Inland Transport Committee

World Forum for Harmonization of Vehicle Regulations

Proposal for Supplement 10 to the 01 series of amendments to Regulation No. 67 (LPG vehicles)

Submitted by the Working Party on General Safety Provisions *

Figure 4
(example only) ($a = 102 \text{ mm}$; $b = 241 \text{ mm}$)

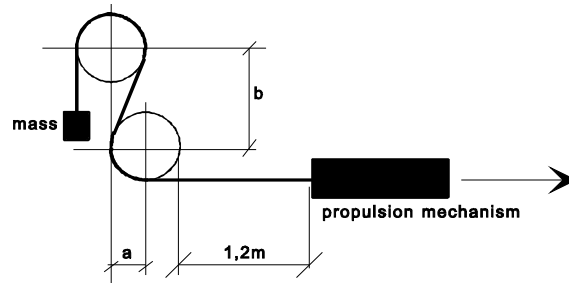
- 4.5.4.2. The testing machine (see Figure 4) shall consist of a steel frame, provided with two wooden wheels, with a rim-width of approximately 130 mm.

- The circumference of the wheels must be grooved for the guidance of the hose. The radius of the wheels, measured to the bottom of the groove, must be 102 mm.

- The longitudinal median planes of both wheels must be in the same vertical plane. The distance between the wheel-centres must be vertical 241 mm and horizontal 102 mm.

- 4.5.4.3. The hose shall be S-shape-like installed over the wheels (see Figure 4).
- The end, which runs over the upper wheel, shall be furnished with a sufficient mass as to achieve a complete snuggling of the hose against the wheels. The part that runs over the lower wheel is attached to the propulsion mechanism.
